# THE COUNTY OF CHESTER

## PLANNING COMMISSION

September 13, 2018

Re: Preliminary Subdivision and Land Development - 1720 W. Chester Pike, L.P.  
# Willistown Township – SD-08-18-15556 and LD-08-18-15557

Site Plan Detail, Sheet 2 (Proposed Subdivision): 1720 W. Chester Pike, L.P.

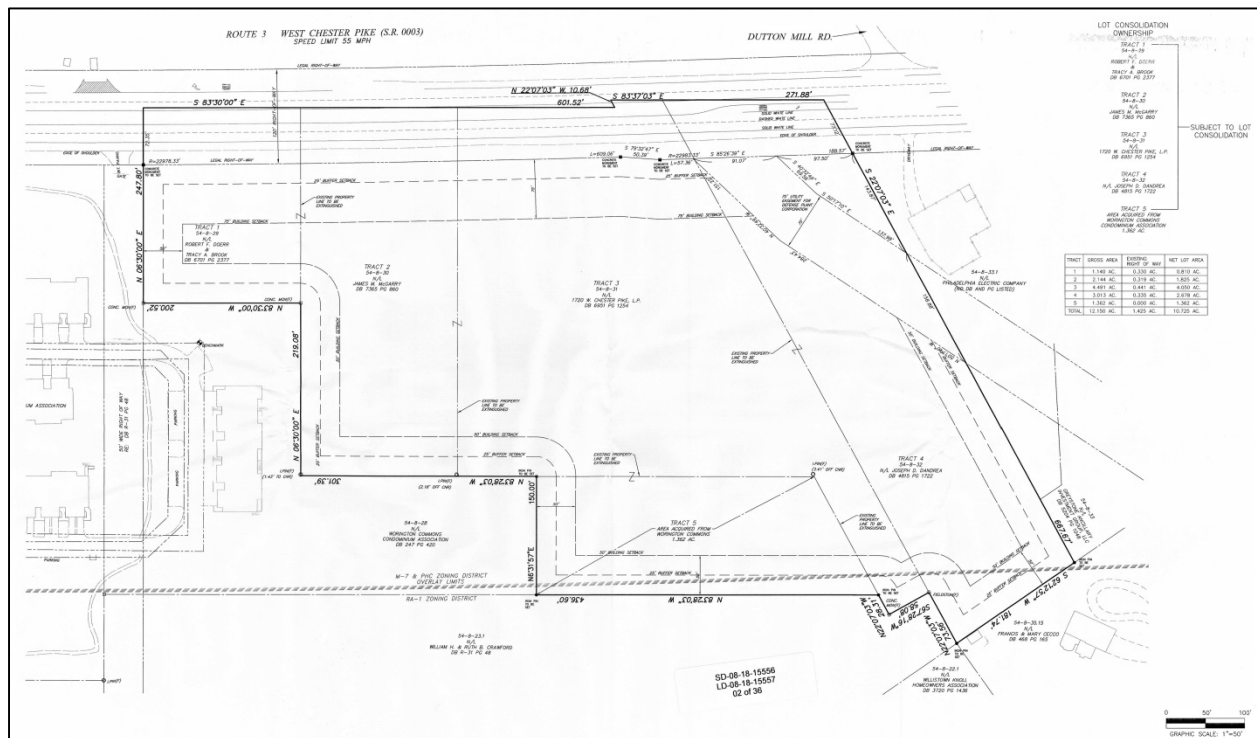
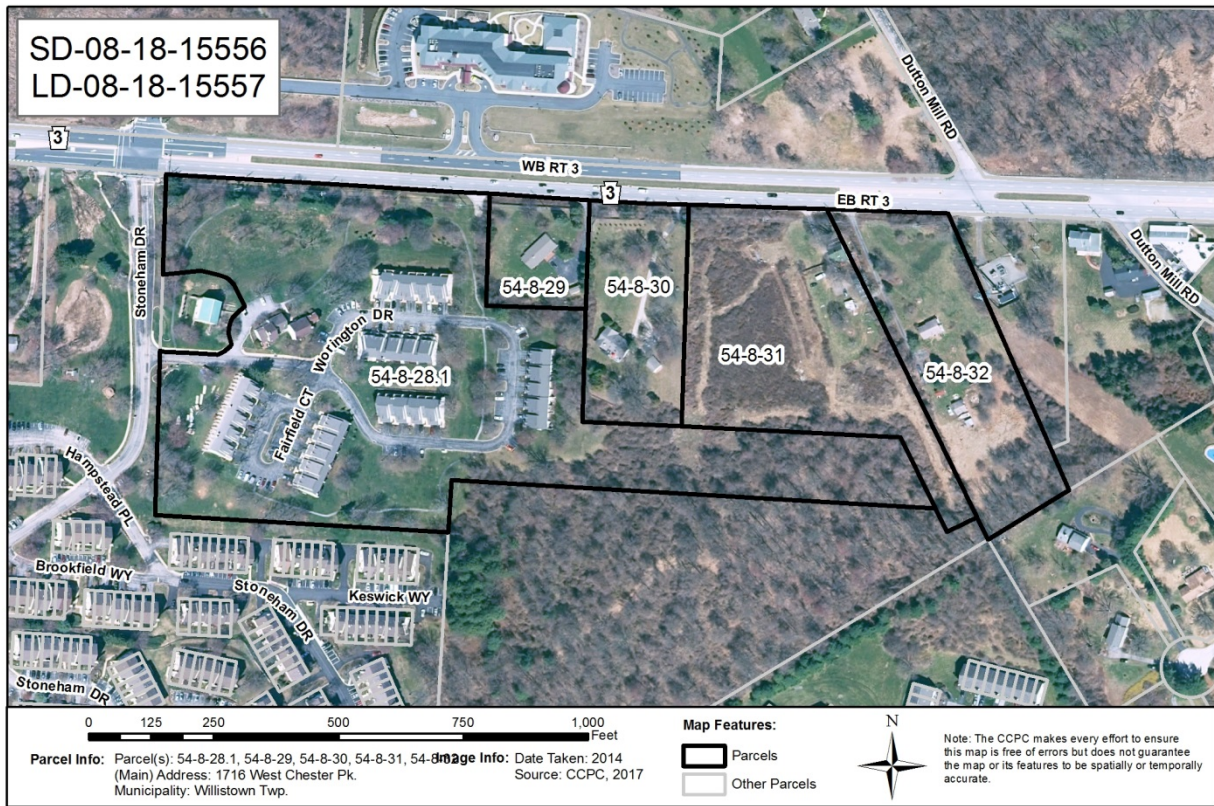
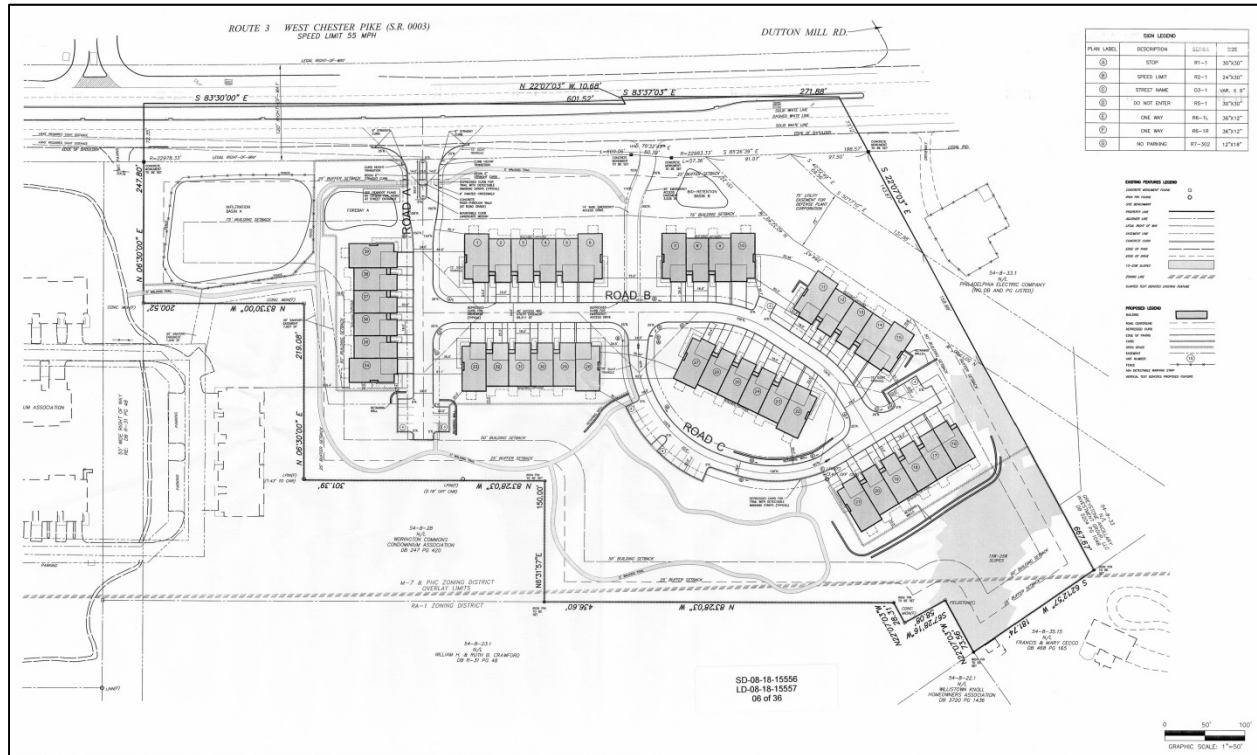
4. The site plan depicts the location of a five foot wide walking trail within the proposed open space, along with a crosswalk within the main driveway entrance. We acknowledge that a Macadam Paved Trail detail is provided on Sheet 20, and we also acknowledge that the proposed trail will extend to the adjoining Worington Commons development to the west. We recommend that all trail corridor location and design details be incorporated into the final plan, and we also recommend that any trails be constructed prior to the Township issuing any building occupancy permits for this development.
5. We recommend that sidewalks be provided for all proposed units, which should provide direct access to the proposed trail network. Sidewalks are an essential design element for new construction in the Suburban Landscape.

6. While we acknowledge that an emergency access connection is being provided, we note that this connection is located approximately 280 feet to the east of the main entrance on Route 3, and that this section of Route 3 is limited to eastbound traffic only. We suggest that the applicant and Township investigate the feasibility of providing an emergency access connection from an adjoining parcel, particularly the adjoining Worington Commons development to the west. Additional information on emergency access is available online at: [www.chesco.org/DocumentCenter/View/27034](http://www.chesco.org/DocumentCenter/View/27034).

7. The site plan depicts an existing 120 foot wide right-of-way for this section of Route 3. The County Planning Commission's Multimodal Circulation Handbook (2016 Update), which is available online at [www.chescoplanning.org/resources/PubsTransportation.cfm](http://www.chescoplanning.org/resources/PubsTransportation.cfm), classifies Route 3 as a major arterial road. The Handbook (page 183) recommends a 150 foot-wide right-of-way for major arterial roads in suburban areas to accommodate future road and infrastructure improvements. We recommend that the applicant and the Township contact PennDOT to determine the appropriate right-of-way to be reserved for this section of Route 3.

10. The site plan depicts the location of a 75 foot wide utility easement in the northeast corner of the project site which contains three transmission pipelines. The Chester County Pipeline Information Center mapping application indicates that these pipelines are: a Sunoco Pipeline (Energy Transfer) hazardous liquids pipeline; an Enbridge natural gas pipeline; and a Laurel Pipeline Company/Buckeye Partners hazardous liquids pipeline. The applicant should contact the pipeline operators to ensure that the application does not result in any encroachments into the pipeline right-of-way. It is recommended that the plan include the field survey location of the pipeline, the size, material and depth (if known), and the type of product typically being transported through the pipeline. Pipeline operator contact information is located on the pipeline markers within the easement and can also be found at the Chester County Pipeline Information Center Pipeline Operators page: [www.chescoplanning.org/pic/introduction.cfm](http://www.chescoplanning.org/pic/introduction.cfm).

14. The site plan depicts the location of several retaining walls. The Township should verify that all necessary ordinance relief measures to permit grading in steep slope areas have been granted and that the design of the slopes is consistent with all ordinance requirements related to permitted grades, the design and specifications of retaining walls and slope stabilization.

16. The site plan depicts the location of a 20 foot wide sanitary easement along the western portion of the project site. The details of this easement should be incorporated into the deed of the proposed lot.
